ENVIRONMENTAL EVALUATION GROUP

December 31, 1997

Mr. Frank Marcinowski
Radiation Protection Division
Office of Radiation and Indoor Air
U.S. Environmental Protection Agency
401 M Street SW
Washington, DC 20460

SUMMARIES OF THE ISSUES PRESENTED ON 12/10/97

Figure 13: Scatter plot of pressure versus total pore volume in the repository. From Helton, 1996.

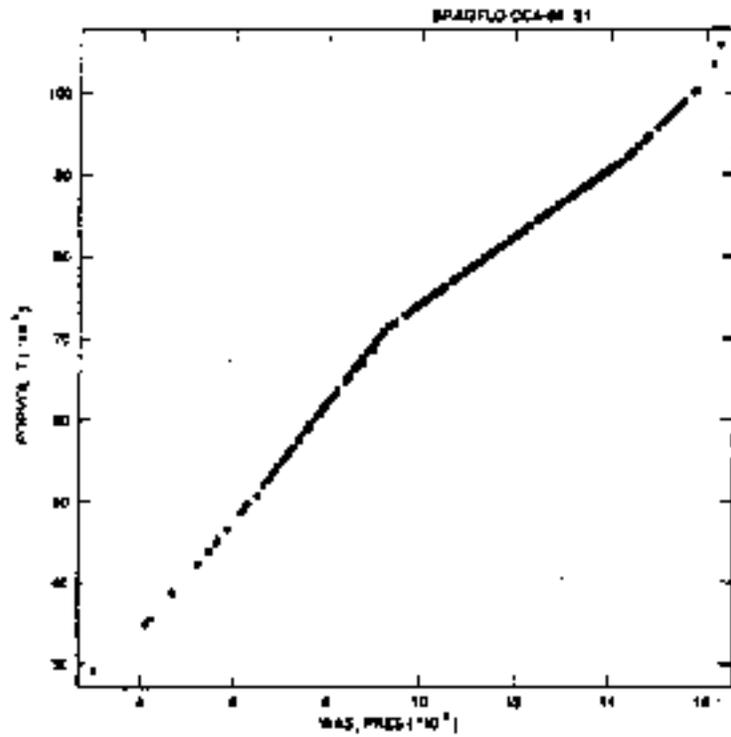
C) The repository inflates as the pressure rises (Figure 13; Figure 2.3.5) leading to more void space and lower saturations per unit volume of brine. Figure 13 indicates that the calculated void space in the repository is twice as large at 12 MPa than at 5 MPa and nearly three times at 16 MPa. Thus, the correlation of brine volume to pressure is much weaker than the correlation of saturation to pressure seen in Figure 4.

Figure 1: Overall Mean For PAVT Increased Spallings

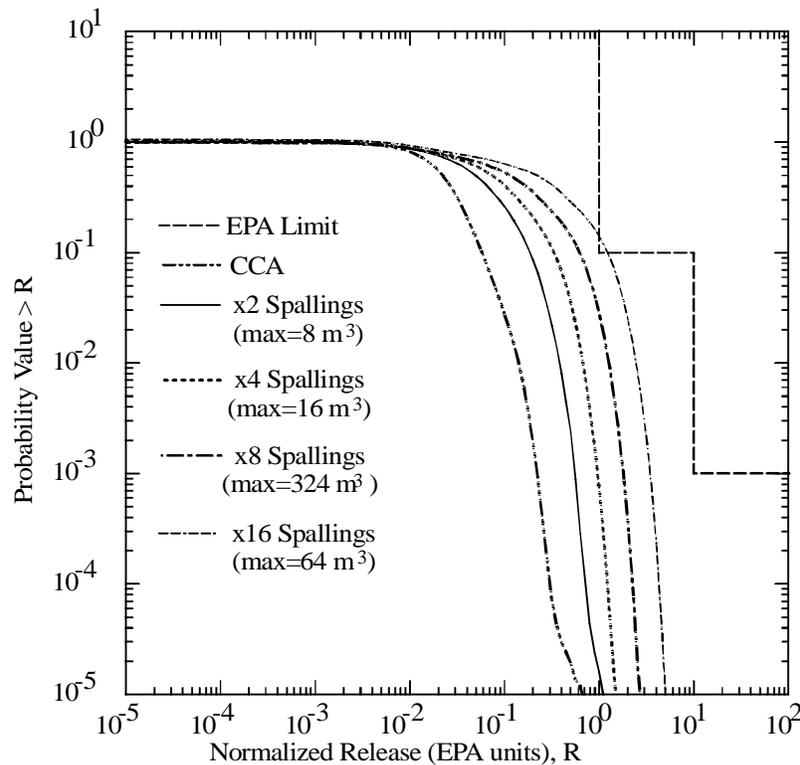
The results of increased spall reaching the surface can be seen in Figure 1. The increase in spall was accomplished by multiplying the PAVT generated releases by a factor of 2, 4, 8, and 16. These curves are seen in Figure 1, and are compared to the CCA releases. The figure suggests that a maximum of 16 times the amount of spallings will cause the repository to fail at the 10^{-1} probability, which corresponds to spallings releases between 8 m^3 and 64 m^3 .

The questions raised on the amount of spalled material that will cause the disposal system to fail compliance is addressed here. The concern of additional spalled material that may reach the surface, by either a stuck pipe / gas erosion process, or through air drilling can be seen in Figure 1. The figure shows that a maximum of 16 times the PAVT spalled release can be brought to the surface before compliance of the disposal system is compromised if other modes of releases are held constant.

Figure 1. Air Drilling Results for 100 vectors of an S3 scenario at 1200 years postclosur

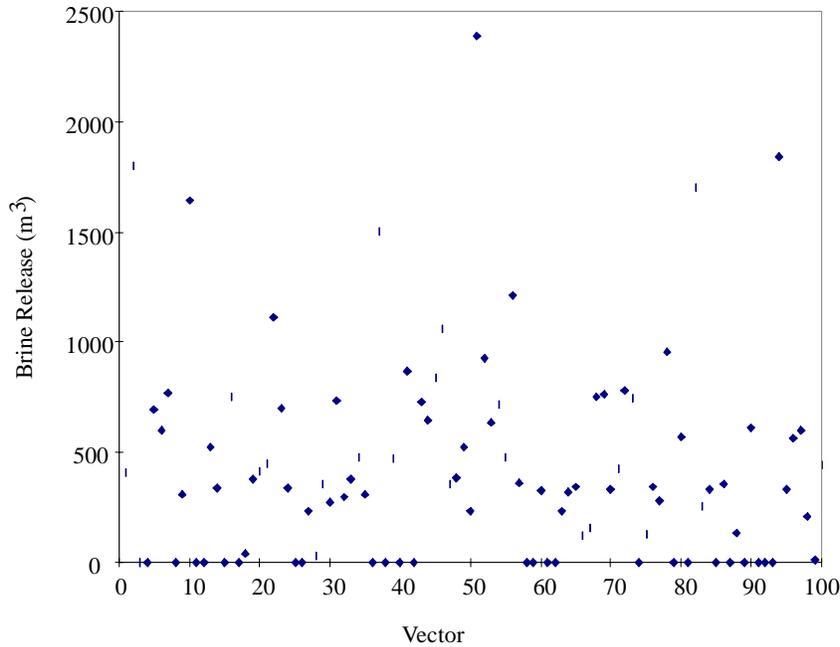
The model was run for an initial E1 intrusion at 350 and 1000 years, and subsequent E2 intrusions at 550, 750, 1200, 1400, 2000, 3000, 4000, 5000, and 10000 years post closure (S2 and S3 scenarios). The results, shown in Figure 1, demonstrates the danger of drilling with air into the repository. The figure shows the results of 100 vectors for time 1200 years for S3, Replicate 1 using air as the drilling fluid. A single realization is shown to release as much as 2400 m³ of brine to the surface at a second intrusion time of 1200 years. This is the highest brine release seen for all vectors at all times. The mean value for all releases at 1200 years is 436 m³. The PAVT results show a maximum of 76 m³ at 1200 years postclosure (DOE, 1997), and the CCA predicted a maximum release of 15 m³ (DOE, 1997).

The high volumes of release seen in Figure 1 can be attributed to the high pressures of the repository. At 1200 years postclosure, the repository pressure of vector 51, which has the highest releases, exceeds most other vectors at 13.3 MPa, and is ranked 4th out of 100 vectors for highest repository pressure. Also contributing to its high release is the waste saturation. Vector 51 has a saturation of 0.67, which has been seen in past sensitivity analyses (See Figure 5.1.5. of Helton, 1996) to be an ideal saturation for release.

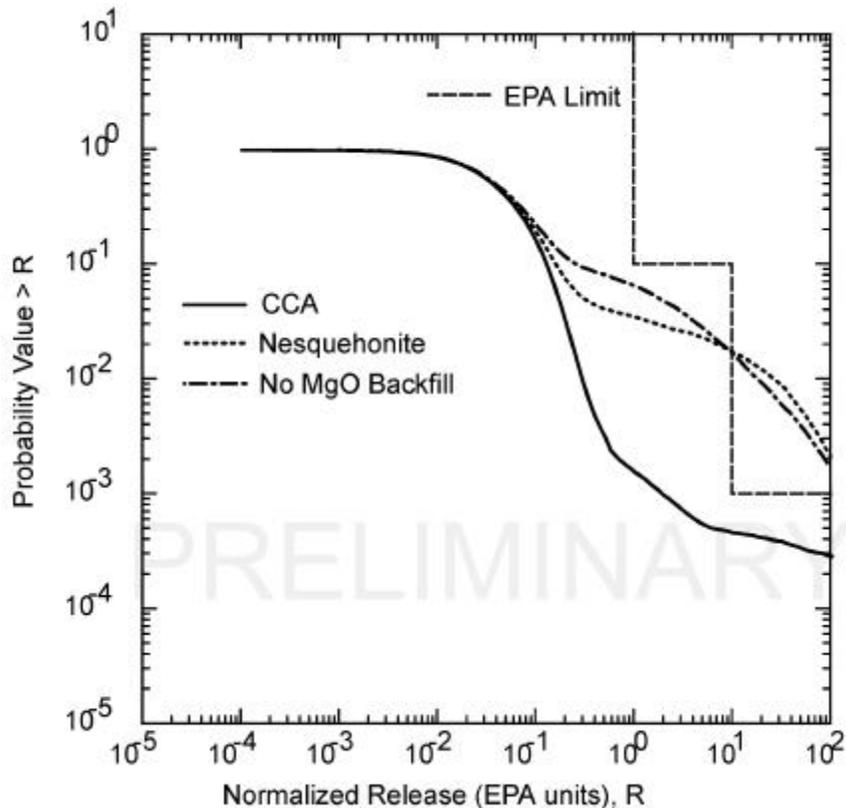
The CCDF curves, using the results of air drilling, can be seen in Figure 2. The code, which produced the curves, used the releases from PAVT and solubilities from the CCA. The direct brine release results of air drilling were then substituted for the results of the PAVT. Again, it should be noted that the CCDF results use spillings releases calculated in the PAVT. Spallings releases due to an air drilling event were not incorporated into the results. These curves assume a worst case scenario, in which all the drilling from an E1E2 drilling event would be using air as the drilling fluid.

The third curve on the CCDF plot shows the response of the disposal system for solubility values from 'No MgO Backfill'. The releases for probabilities greater than 1 in 50 are much higher than the other two curves. However, at lower probabilities the 'No MgO Backfill' has lower releases than the solubilities with Nesquehonite. This is due to the difference in solubility values at the +4 oxidation state for both Salado and Castile brine. In conclusion, the CCDF curves are shown to cross the EPA Release limits for higher solubility values, and the issue of air drilling must be taken more seriously than previous evaluations.
